U.S. Department
of Transportation
**Federal Highway
Administration**

In Reply Refer To:
HSST/B-218

Name of system: F-Shape Reinforced Concrete Barrier with Slotted Drain Holes
Type of system: Permanent F-Shape Reinforced Concrete Barrier
Test Level: National Cooperative Highway Research Program (NCHRP) Report 350
Test Level 4 (TL-4)

Testing conducted by: Texas Transportation Institute (TTI)
Date of Request: December 9, 2010
Drawing Designator: SBC04d

Figure 76 – LaDOTD F-Shape Barrier, TXDOT Wildlife Crossing Barrier WSDOT Pin & Loop Barrier Cross-Sections

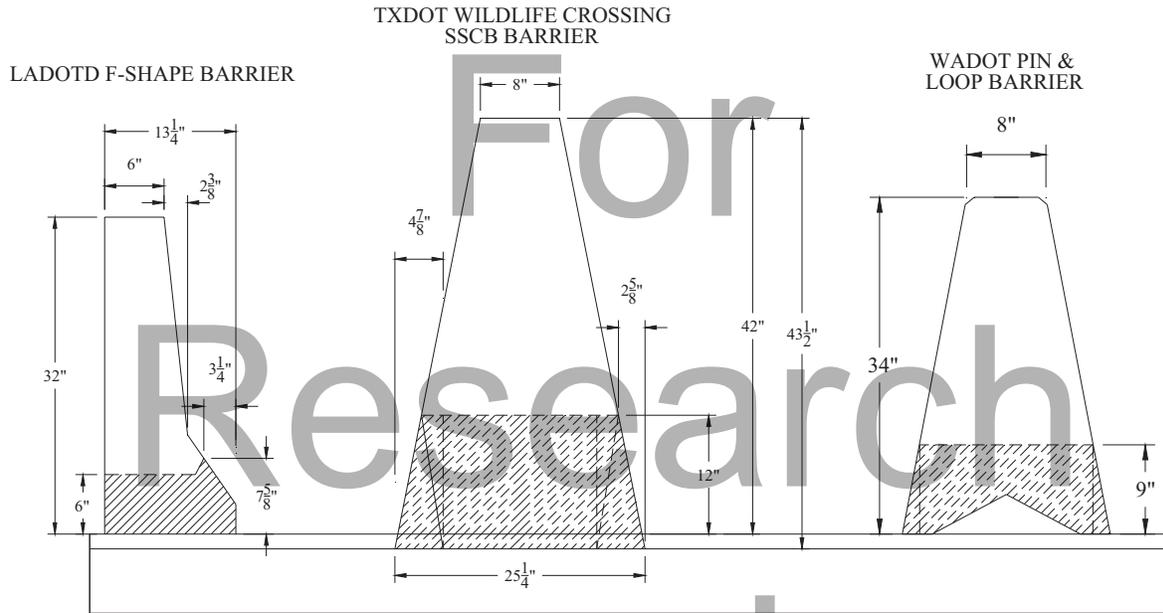
The ratio in height of the contact length of the F-Shape Barrier to 32 inches total height of rail (i.e., rail contact width to height) is 0.762. Based on the proposed barrier geometry and the information provided in AASHTO Figure A13.1.1-3, the proposed barrier is considered marginal.

Details including a side-by-side comparison between size openings of TXDOT Wildlife Crossing Barrier, WSDOT barrier, and LaDOTD F-Shape Barrier with drainage slots are provided as enclosure to this correspondence.

Therefore, the system as described in the request above and detailed in the enclosed drawings is acceptable for use on the NHS under the range of conditions tested, when such use is acceptable to a highway agency.
